Alternative Study for the WSSC Potomac Mid-River Submerged Channel Intake: Mandatory Referral

Staff Recommendations: Approval to transmit comments to WSSC

Alt 2 – Tunnel to shaft west of intake

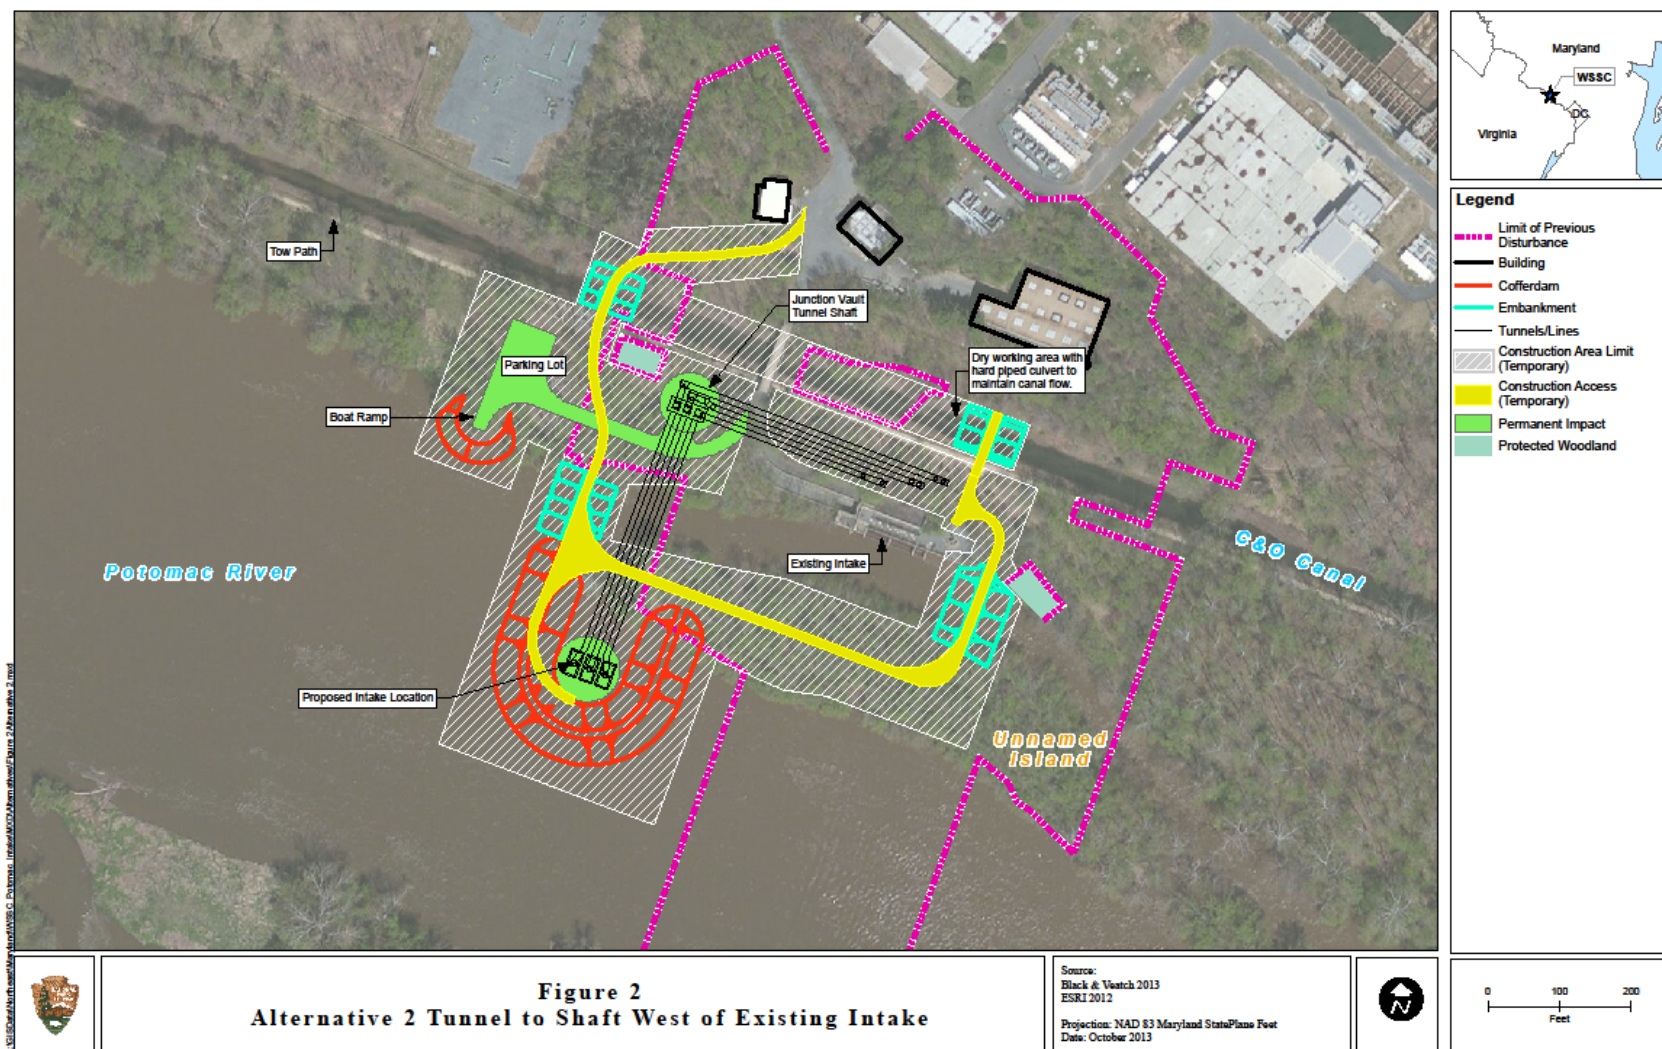
1. Permanent surface impact to the Potomac River shoreline such as
 - a. parking lot and boat launch to be used for maintaining the new intake facility (common to all alternatives)
 - b. access road to the canal towpath for maintenance of the shaft (alternative 4)
 - c. junctional vault access shaft (common to all alternatives but with different locations)
2. Large limits of disturbance area associated with alternative 4.
3. Potential impacts to National Park Service ownership of certain land areas.

1. Submit a Mandatory Referral for the design phase.
2. Minimize all permanent impacts to the Potomac River shoreline, especially those that will be clearly visible from the Tow path and the River channel.
3. Minimize the size and duration of all temporary construction impacts.
4. Minimize land removed from the Chesapeake & Ohio (C&O) Canal National Historical Park and Trail
